MFN 09-263

Subject: Submittal of Response to Portion of NRC Request for Additional Information Letter No. 310 Related to ESBWR Design Certification Application Chapter 18 - Human Factors Engineering - RAI Numbers 18.8-2 S03, 18.8-35 S04, 18.8-50 S02, 18.8-51 S02, 18.8-52 S02, 18.8-53 S01, 18.8-54 S01, 18.8-55 S01, 18.8-56 S01, 18.8-57 S01, 18.8-58 S01, 18.8-59 S02.

**Response to Portion of NRC Request for
Additional Information Letter No. 310
Related to ESBWR Design Certification Application**

Chapter 18 - Human Factors Engineering

Figure 2. Human-System Interface Design Implementation Process

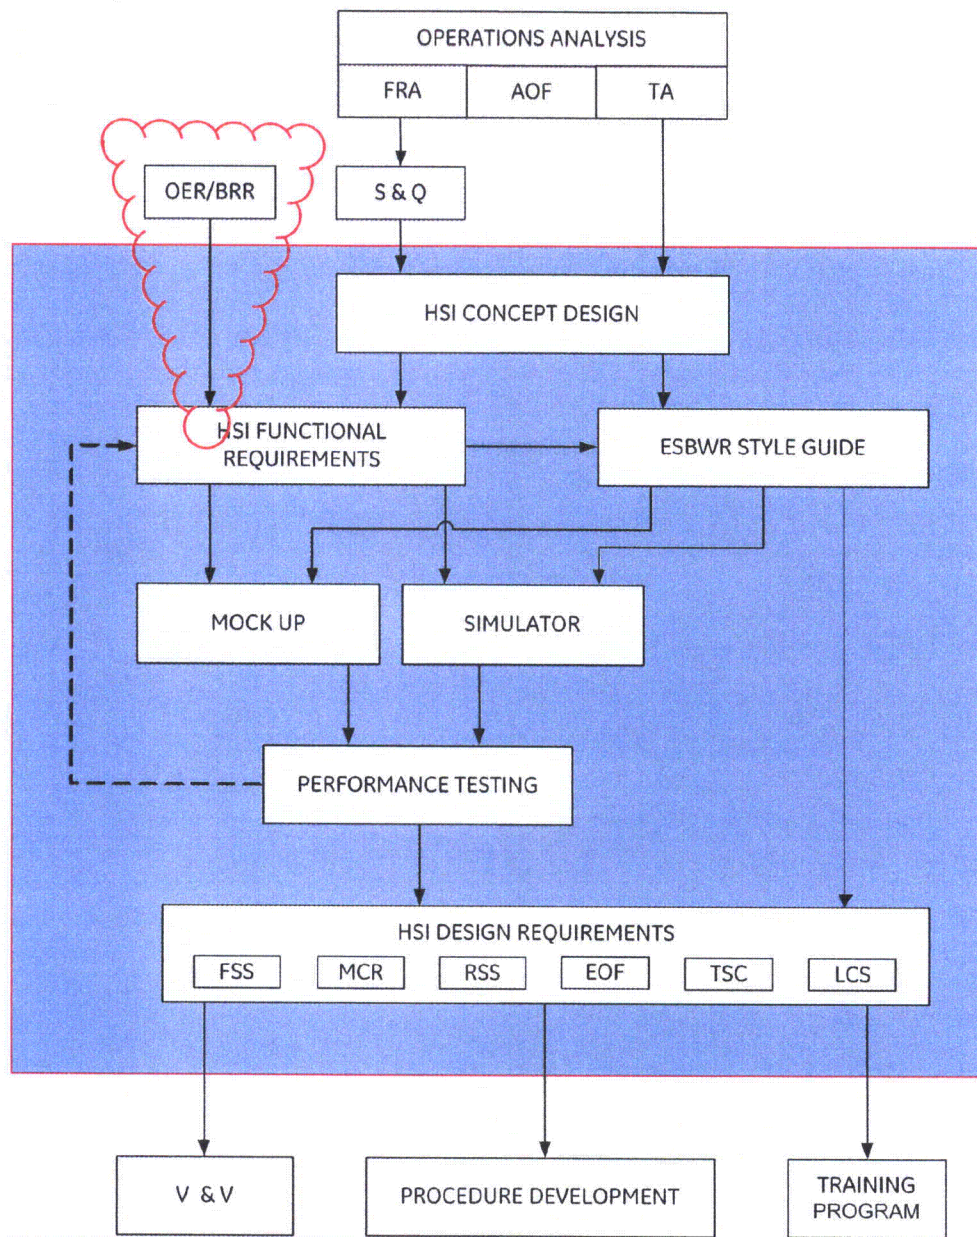
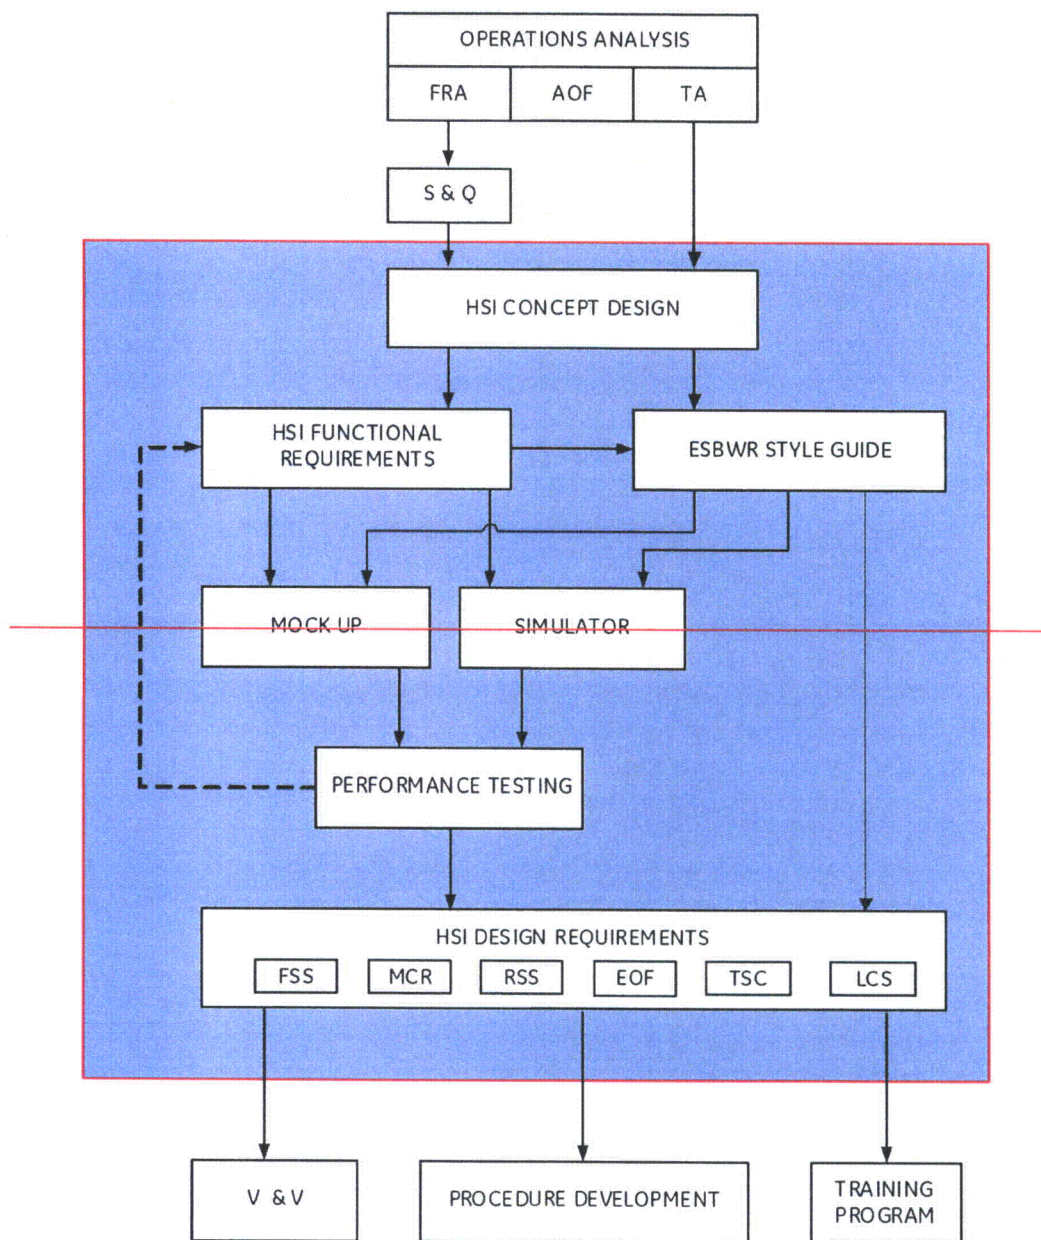
NEDO-33268, Revision 3, Section 3.1.3 discusses HSI functional requirements for the HSIs in terms of their bases and application to HSIs reflecting the two review criteria in this section. Figure 2 graphically illustrates the relationship between HSI functional requirements and other HSI design activities. Inputs to HSI functional requirements development are shown as functional requirements analysis (FRA), allocation of function (AOF), task analysis (TA) and staffing and qualifications analyses. Additional information is provided in Section 4.1.2 in terms of the contributions of FRA, AOF, TA and staffing and qualifications analyses to requirements development. In MFN 08-655, GEH provided an example of one input to the requirements development – Operating Experience Review (OER). However, OER is not identified in Section 3.1.3 or in Figure 2. OER is discussed in Section 4.2.2 as an appropriate input to concept design development, but not to HSI requirements. Clarification is needed.

- Section 3.1.3 will be revised to better indicate the OER input directly into the HSI requirements.
- Section 4.1.2 will be revised to indicate that OER is used to support development of HSI design requirements.
- Figure 2 will be revised to show OER input into the HSI functional requirements.
